EASTCONN COMMERCIAL KITCHEN PROJECT  
HAMPTON, CT

**ADDENDUM ONE**

August 6, 2019

**EVELYN COLE SMITH ARCHITECTS, LLC**

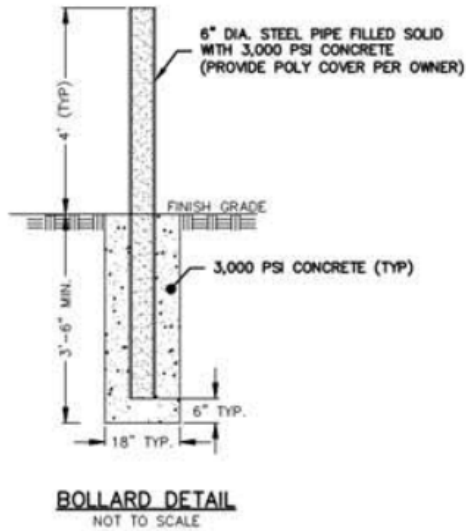
1. Are bollards to be provided around the new propane tank pad? If yes, how many?  
**Response:** Bidder shall carry the cost to install up to 5 bollards on the parking lot side of the

proposed propane tank. See detail herein.
